WILDFLOWER SOCIETY OF WESTERN AUSTRALIA (Inc)

22nd December 2023

CPS 9352/1 Co-operative Bulk Handling Limited application for a purpose permit to clear 1.7ha for construction of a rail siding and fixed loading facility within the Shire of Moora.

Figure 1. New proposed clearing area (highlighted purple) and proposed removal of clearing area CE TEC (highlighted green).

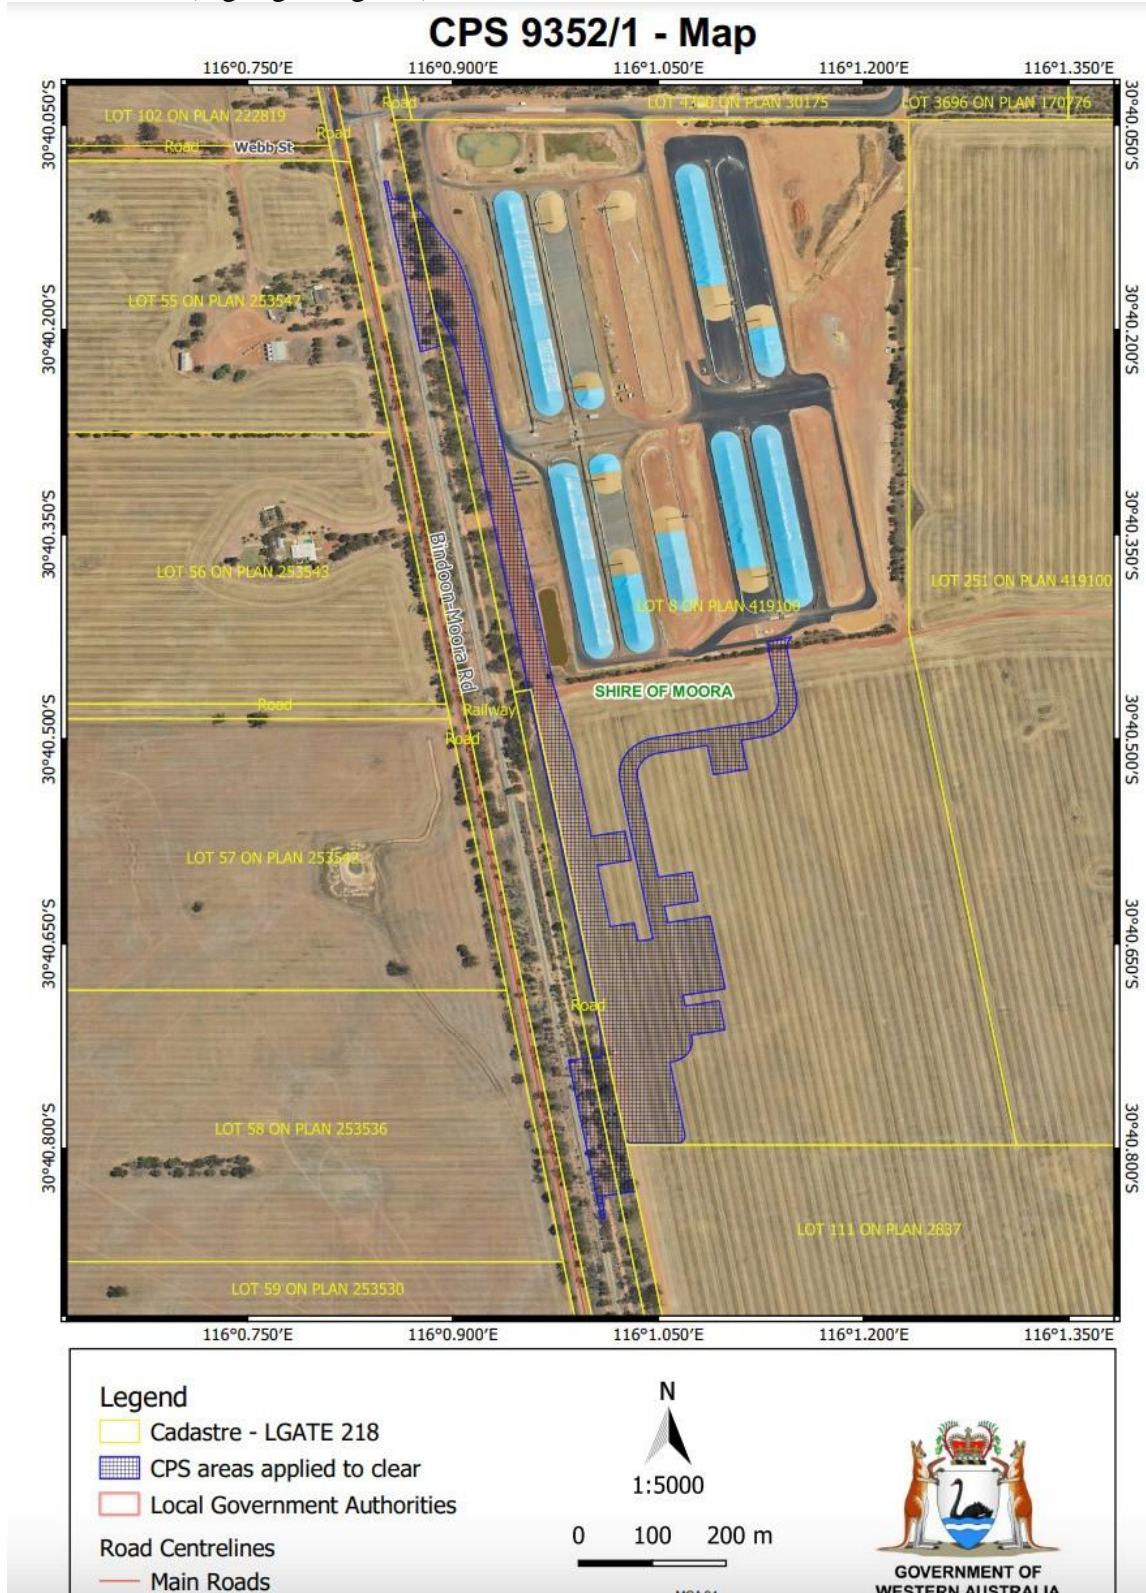
According to DER's 'A guide to the assessment of applications to clear native vegetation' (EP Act, 1986), "*Native vegetation clearing should only be considered after all other reasonable attempts to mitigate adverse impacts have been exhausted*". The Society has included an alternate option that reduces the extent of clearing and the impacts exponentially in comparison to the currently approved proposal. Due to the lack of information supplied regarding the specific intention for the areas proposed to be cleared, the Society has assumed where the proposed railway siding and new processing facilities will be constructed. (Appendix A. Fig. 1).

- The Society proposes that the two rail siding connections are removed and only one connection between the existing railway and the proposed siding is implemented. The current siding connections propose to clear CE TEC and critical habitat for the Endangered CBC, by moving the rail connection in between the two proposed

connections, it will be situated in the vegetation community EcG; *Eucalyptus camaldulensis* scattered trees on Grassland (see Appendix A, fig 1, 2, 3).

Figure 5. A satellite photo of CBH Kwinana Terminal where a rail loop is present. Inspiration for replication on cleared pastoral land in the Shire of Moora, avoiding CE TEC Woodland.

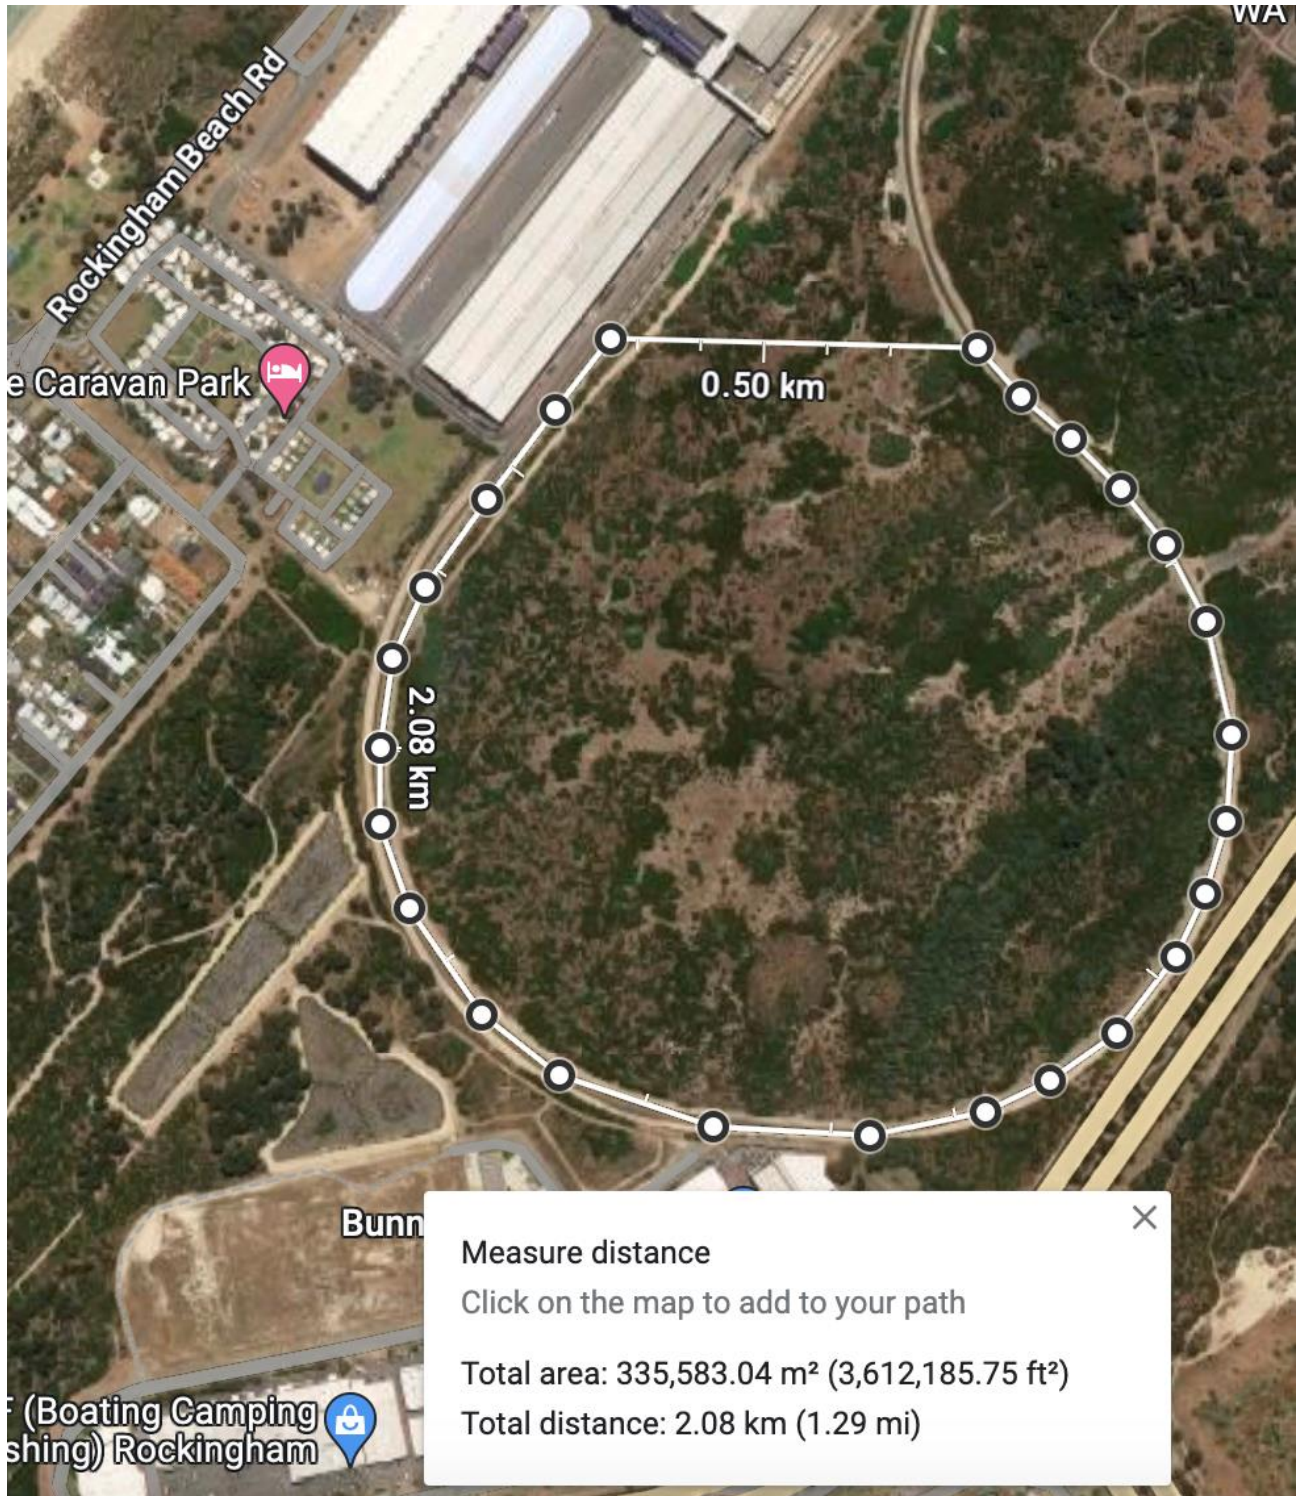
- The Society proposes that the option of a rail loop is implemented on the pasture land that CBH acquired for this project (fig. 4), adjacent to the existing facilities. This allows for freight trains to enter CBH's rail siding, load, and proceed to turn around on the rail loop, finally exiting back on to the existing railway through the singular connection track, inspired by CBH's Kwinana Terminal (fig.5).
- This AO will result in significantly smaller impacts to the Black Cockatoo species (specifically, En CBC); by only removing a total of two trees, one *Eucalyptus camaldulensis* (DBH<50cm, no hollow) and one *E. wandoo* (DBH >30cm, no hollow); as well as resulting in no clearing or direct impacts to the TEC Euc. Woodlands.
 - The vegetation community EcG is rated in lower condition than the TEC; in 'Good' condition and is not of conservation significance.

Figure 4. Alternative option to clearing TEC Eucalypt Woodland, where there is only a singular connection made feasible by the turning loop, instead of a straight rail siding requiring two connection points to the existing rail. Inspired by the CBH Kwinana Terminal, where it has been 'replicated' of a slightly larger size to visualise its feasibility (see fig. 5.).
